No. 98-11

Required MIE 7.4L MPI (L29) ECM Replacement

1998 MIE 7.4L MPI (L29) Inboard Engines: S/N 0L002006–0L007302

72801

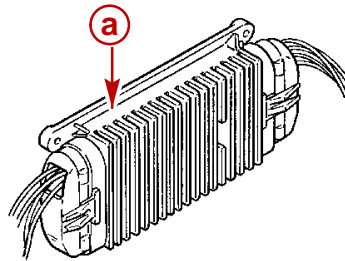
An ECM with a check sum number of A194 is good and it does not need to be replaced. If the ECM has any other check sum number, it must be replaced.

a - Check Sum Number On White Tag - A194 Is The Correct ECM.

861736T 1 ECM (A194)
